Disney Sweater Ltd. (Extension)

Barpa, Rupshi, Rugganj, Narayanganj, Bangladesh.
(23.747123, 90.535561)
29th July 2019

Observations

Shed 11

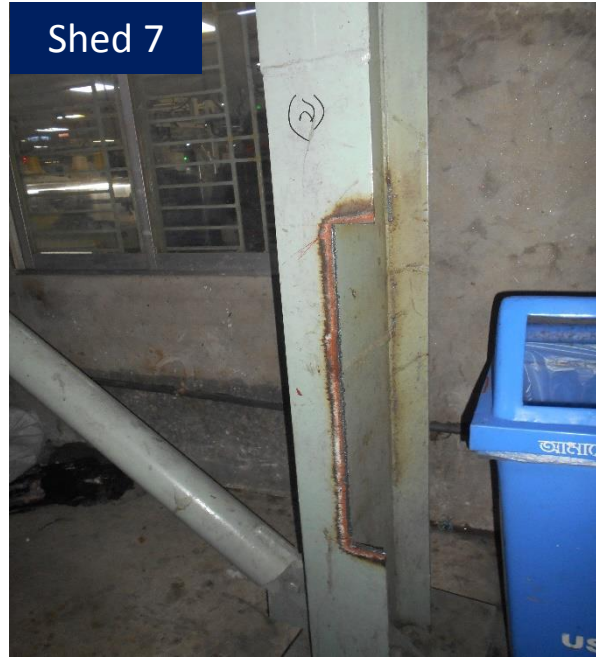
Sample taken from column for tensile test of M/S plate but not refit with identical member.

Item No.	Observation	Recommended Action Plan	Recommended Timeline
7	As-built documents.(Shed-9 Finishing)	Building engineer is required to prepare as-builts drawings which reflects the site condition.	6-weeks
8	As-built documents.(Shed-9 Finishing)	Building engineer is required to check the stability of the shed or replace the shed by an engineered shed.	6-weeks
9	As-built documents.(Shed-9 Finishing)	Carry out remedial works as per recommendation of engineering assessment report.	6-months
10	Steel plate sampling from column.(Shed-2,6,7 &11)	Building engineer is required to refit the columns by identical members.	6-weeks
